# WATER QUALITY MEMORANDUM

## Utah Coal Regulatory Program

RE: Fourth Quarter of 2014 Water Monitoring, PacifiCorp, Trail Mountain Mine, C/015/0009, Task ID #4752

Figure 1. The head in TM-1B slowly began rising in early 2003. It's difficult to say where this value will come to rest.

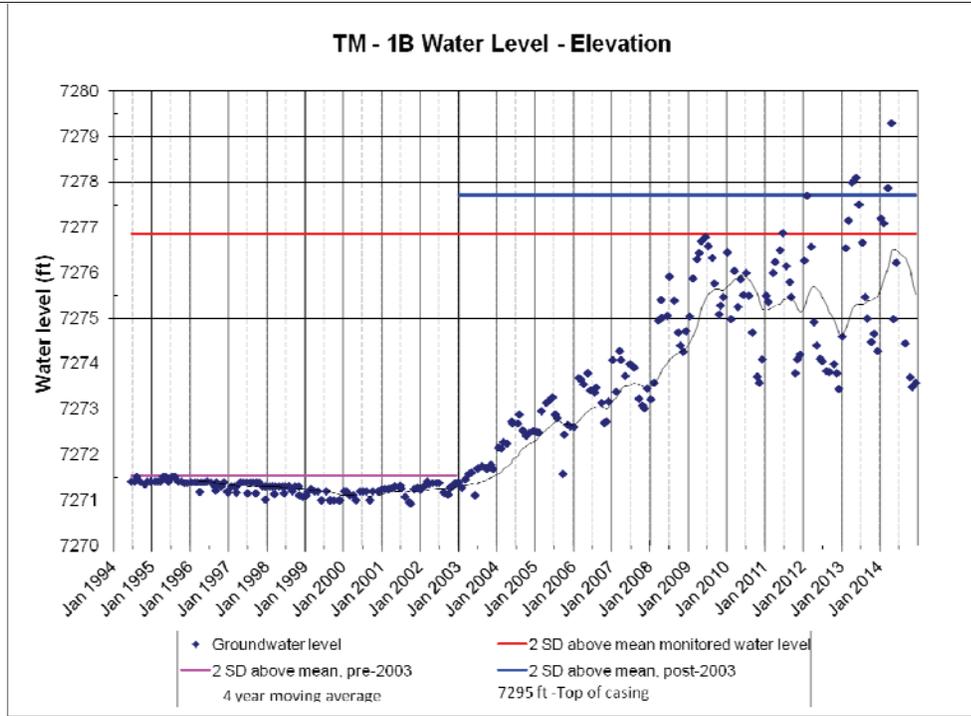
TM-1B is monitored for water level monthly and for operational parameters quarterly (Figure 1). Since July 2004, the water level in TM-3 has been reported as piezometric head above the well casing by measuring the pressure on top of the sealed wellhead with a gauge (Figure 2). CCCW – 1A, CCCW –

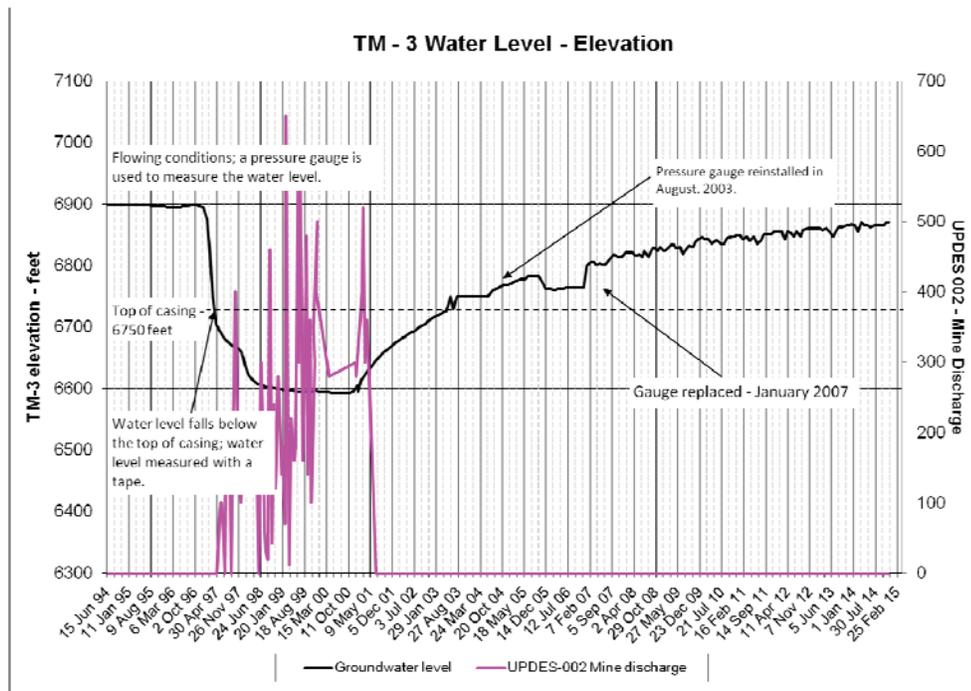
Figure 2. TM-3 water elevation peaked in June 2005, remained steady through October, dropped 18.5 ft in November and December 2005 and remained virtually unchanged during 2006. The pressure gauge was replaced in January 2007 and values jumped to approximately match the pre-2006 curve. During the first half of 2007 the curve was relatively flat, but it has been steadily climbing. The outgoing document Reduce Hydrologic Monitoring Sites, PacifiCorp, Deer Creek, C/015/0018, Task ID #4332 stipulates this well should not be released until 6,900 ft is reached.

Figure 3. Water levels in Cottonwood Canyon Creek monitoring wells.

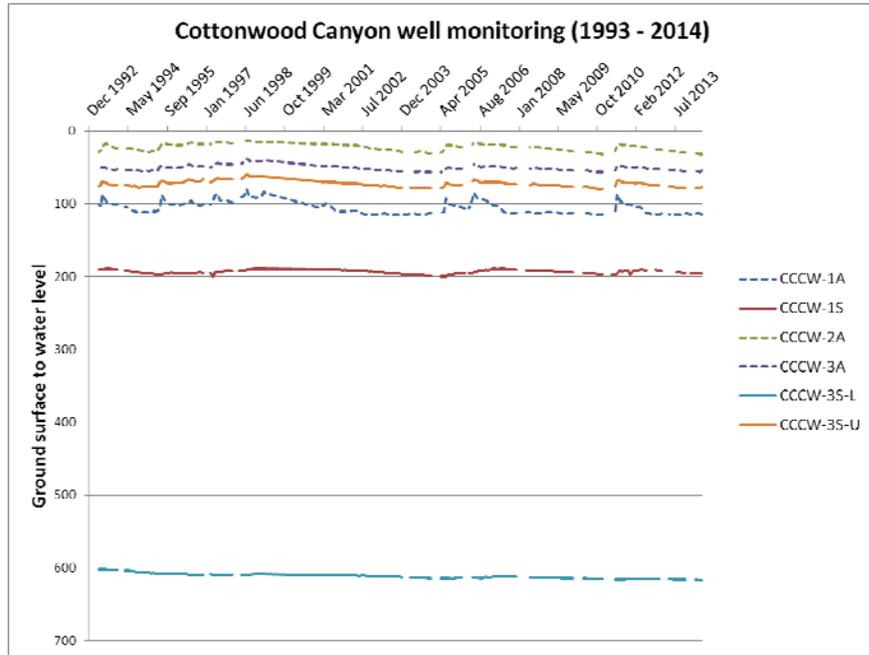
1S, CCCW – 2A, CCCW – 3A, CCCW – 3U, CCCW – 3L are monitored for water level only (Figure 3).
